GRADING & DRAINAGE PLAN

Clark Consulting Engineers		19 Ryan Road Edgewood, New Mexico 87015 Tel: (505) 281-2444 Fax: (505) 281-2444	
DATE _____ REVISION _____ _____ _____ _____		LOTS 43 AND A, BLOCK 3C, FRANCISCAN ADDITION ALBUQUERQUE, NEW MEXICO 2401 EDITH BLVD, NE Grading & Drainage Plan	
DESIGNED BY: PWC CHECKED BY: PWC	DRAWN BY: OCE DATE: 1/30/15	JOB # : TJC-FRENCH FILE # : G/D 1 OF 1

**Re: French's (TLC)
2401 Edith Blvd NE
Grading and Drainage
Engineers Stamp Date 2/2/2015 (H15D058)**

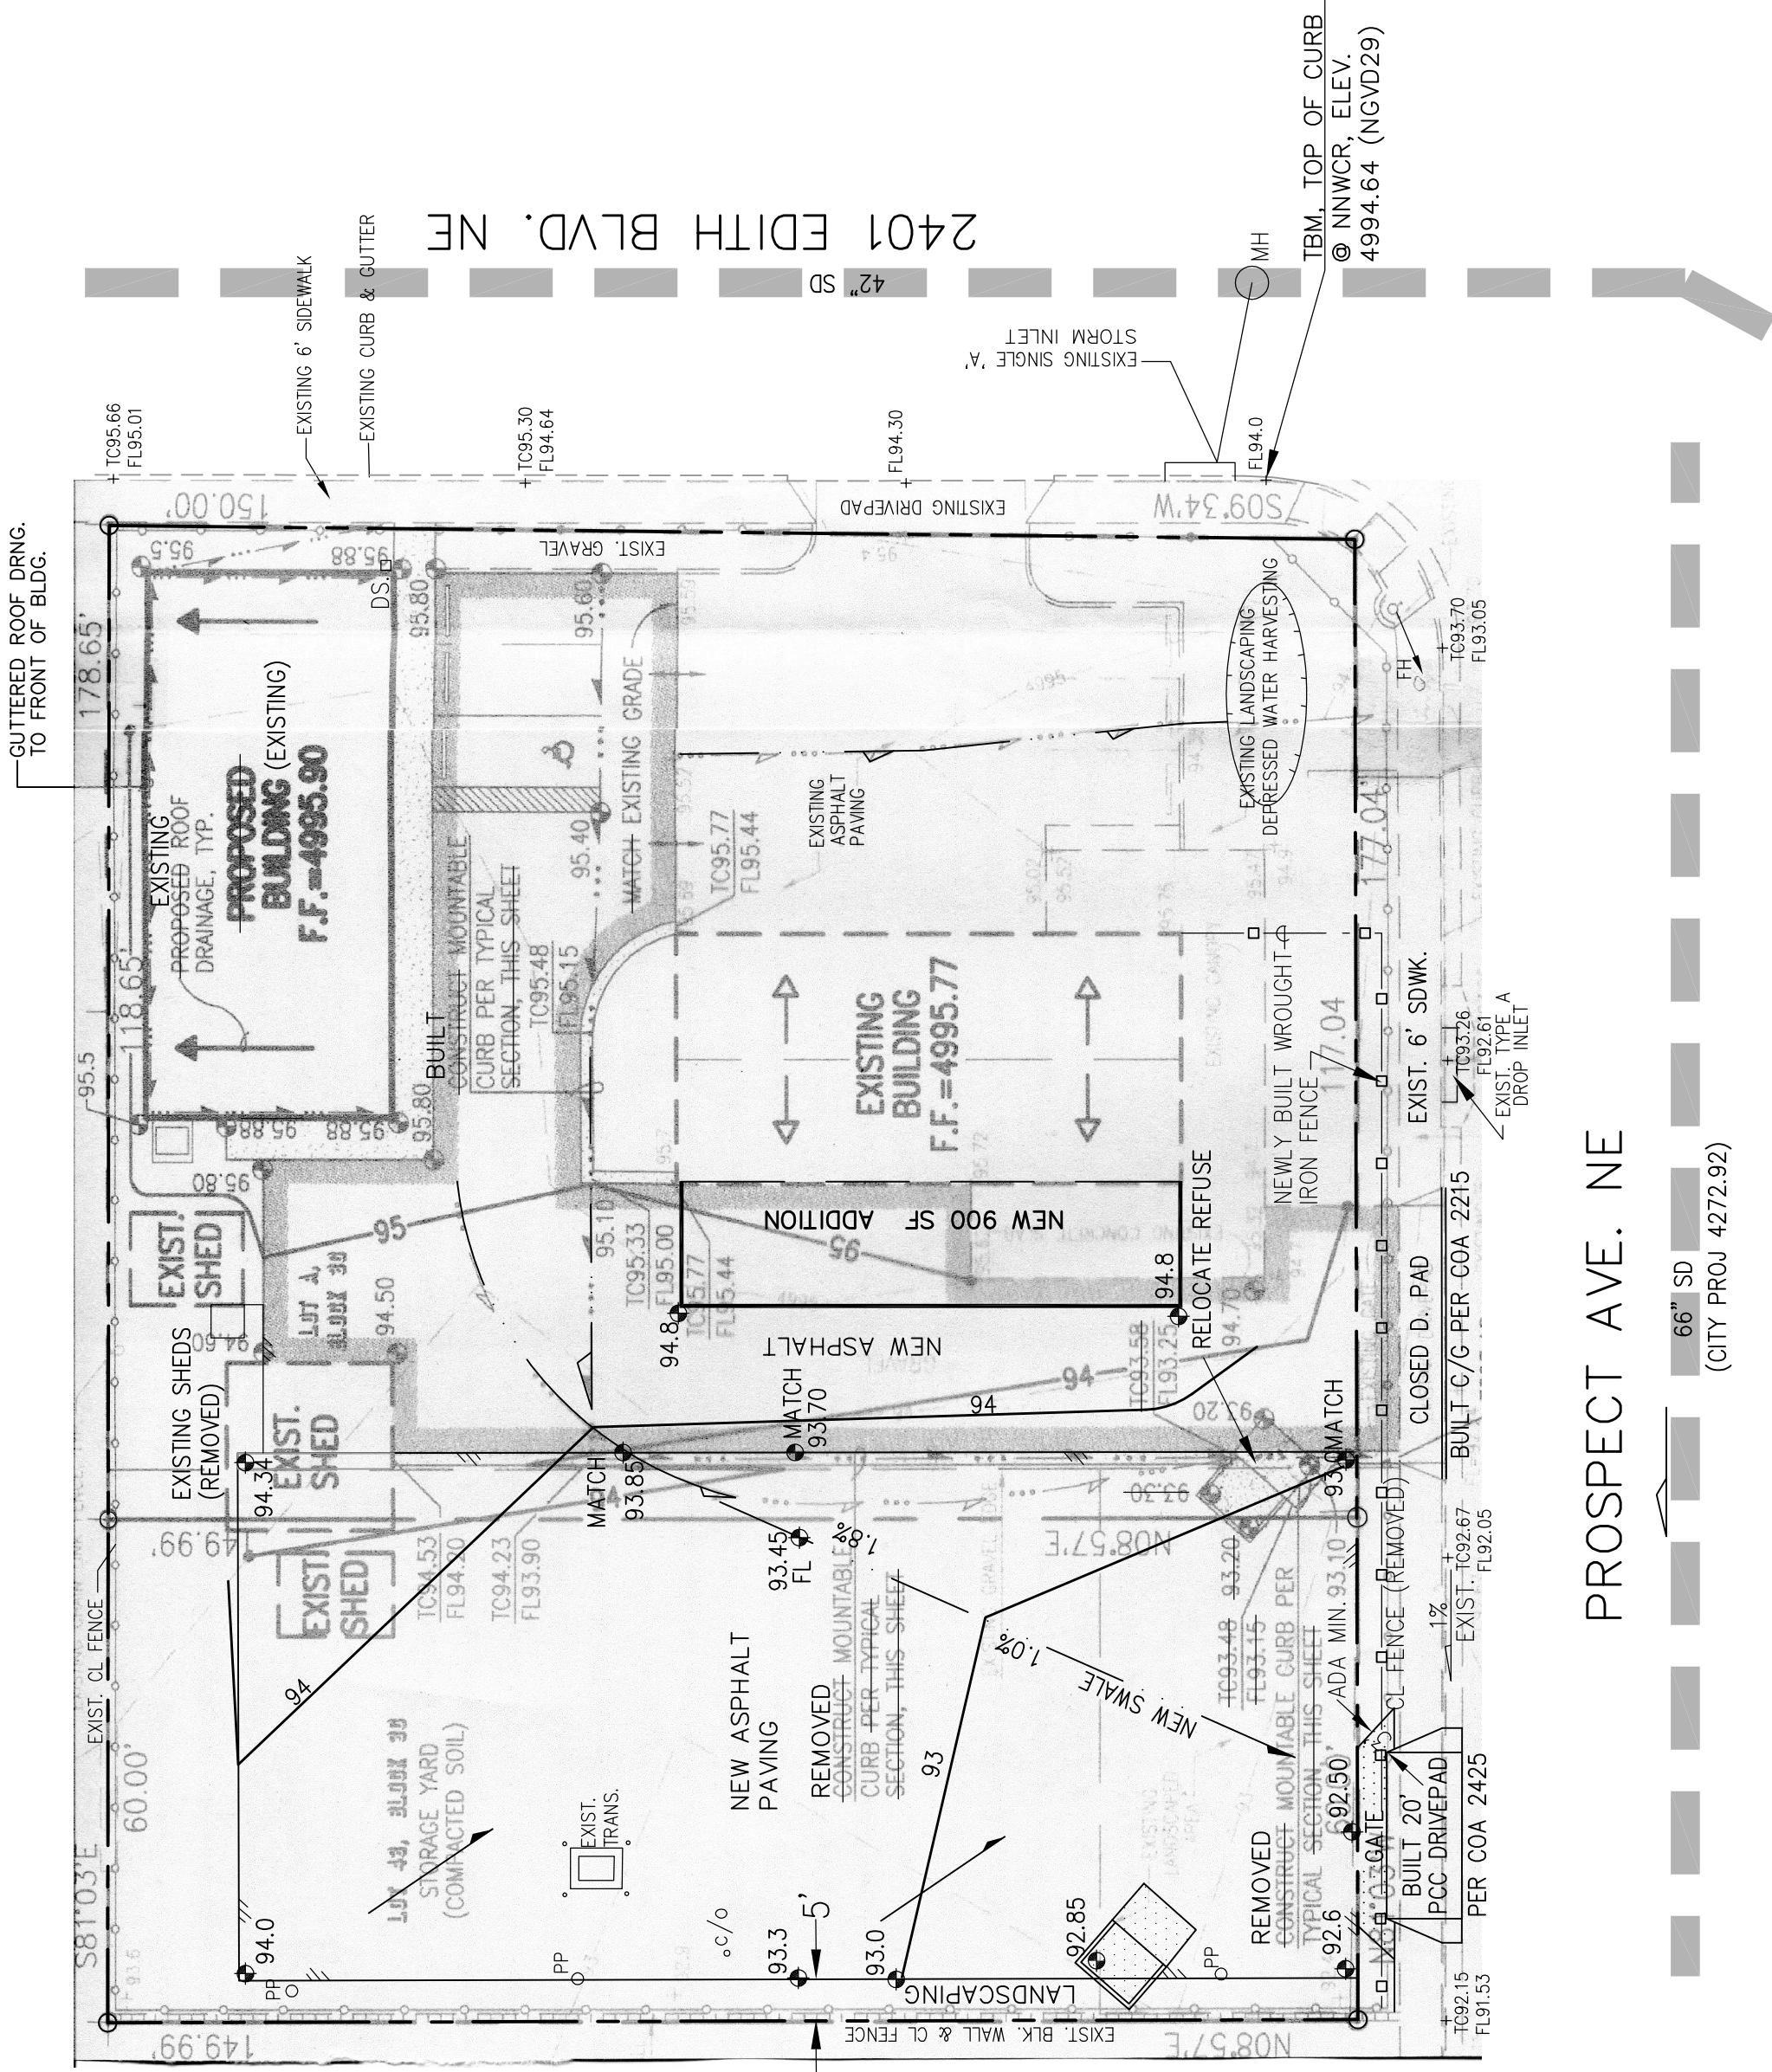
- Mention of the "First Flush" for the new impervious area needs to be on this plan.
- The new impervious area must flow through a retention pond before leaving the site for "First Flush" purposes. The amount which should be provided for the "First Flush" is, .34 times the impervious area. It appears that the new asphalt paving can drain to the west into the landscape buffer then head south via an earthen swale, then leave the site by sidewalk culvert or out the drive pad.
